## FLIGHT MANUAL Supplement No 12

### Electronic accelerometer

**Doc. No: B2-OL-03\_uz12-EN**

NAME-TYPE/MODEL: MDM-1 FOX

Fig.7.1 Front seat view.

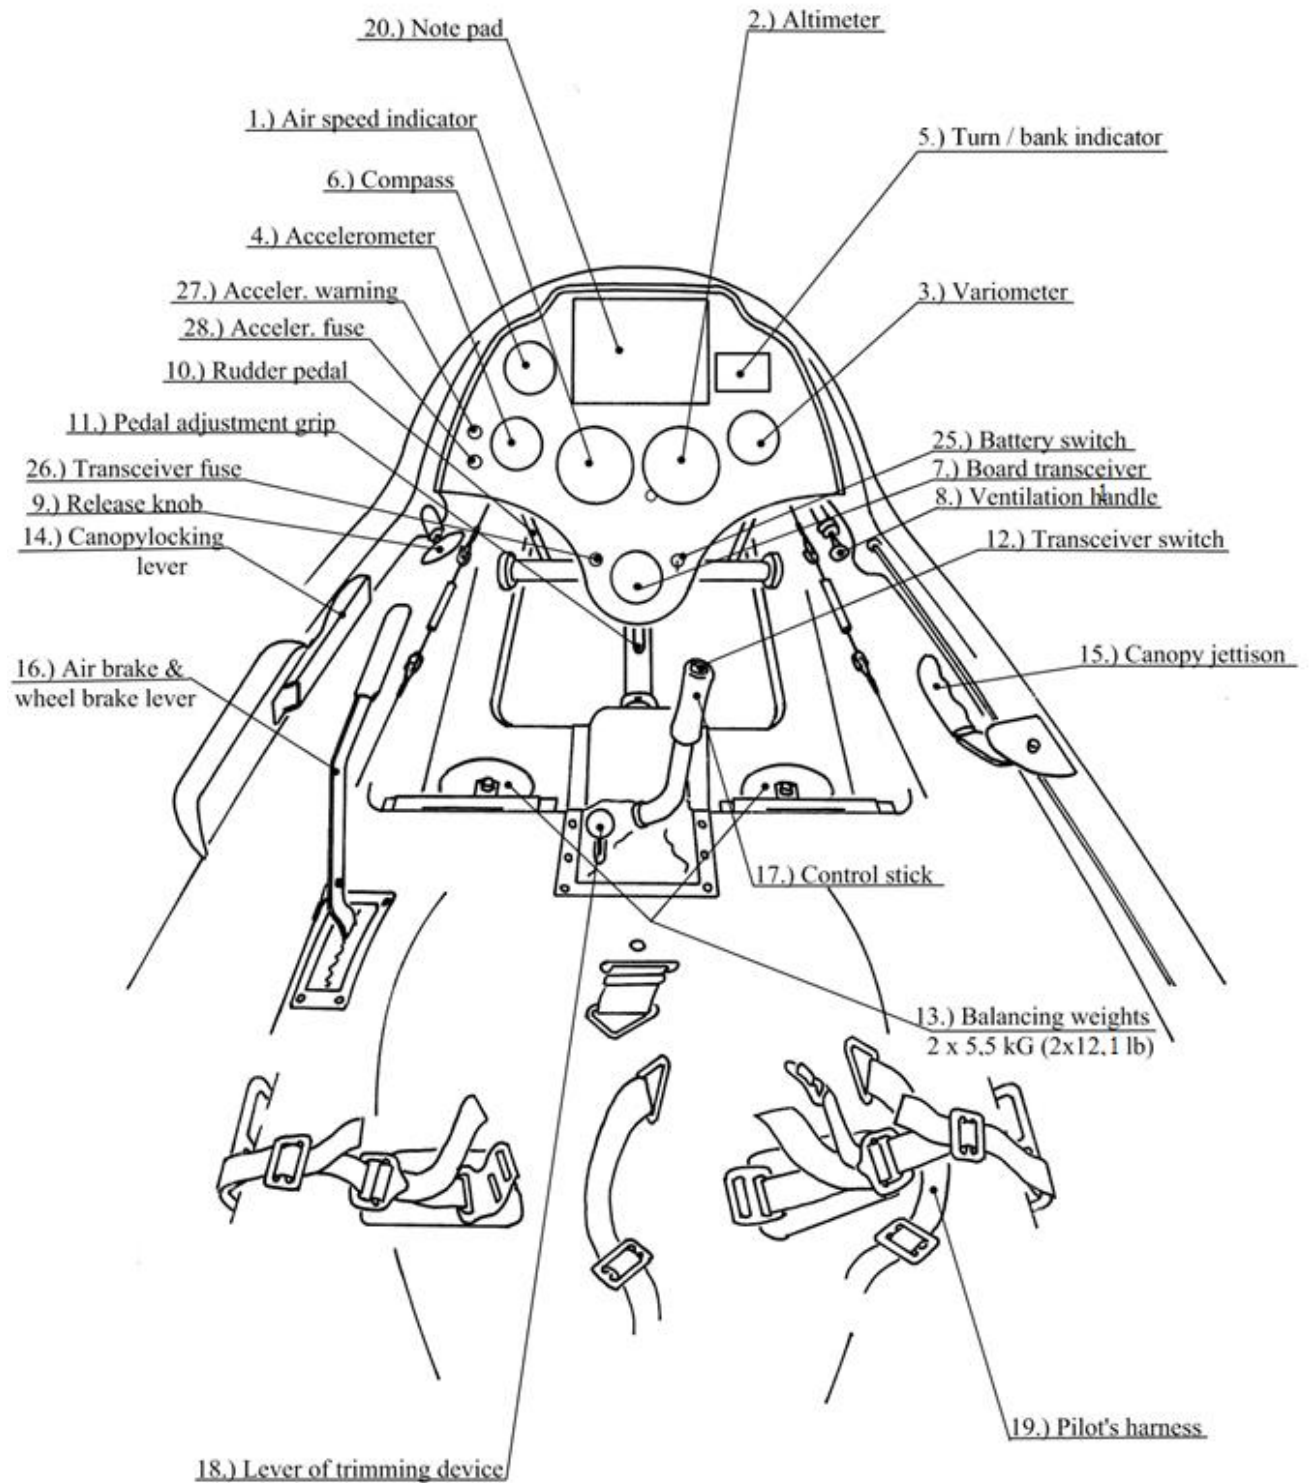
Installation of an electronic accelerometer on a glider entails changes in the arrangement of the instrument panel elements and in the glider's electrical system.

In Section 7, information on the installation of the instrument models used in the project was added, including the arrangement of devices in the front and rear cockpits and the wiring diagram for the glider with electronic accelerometers.
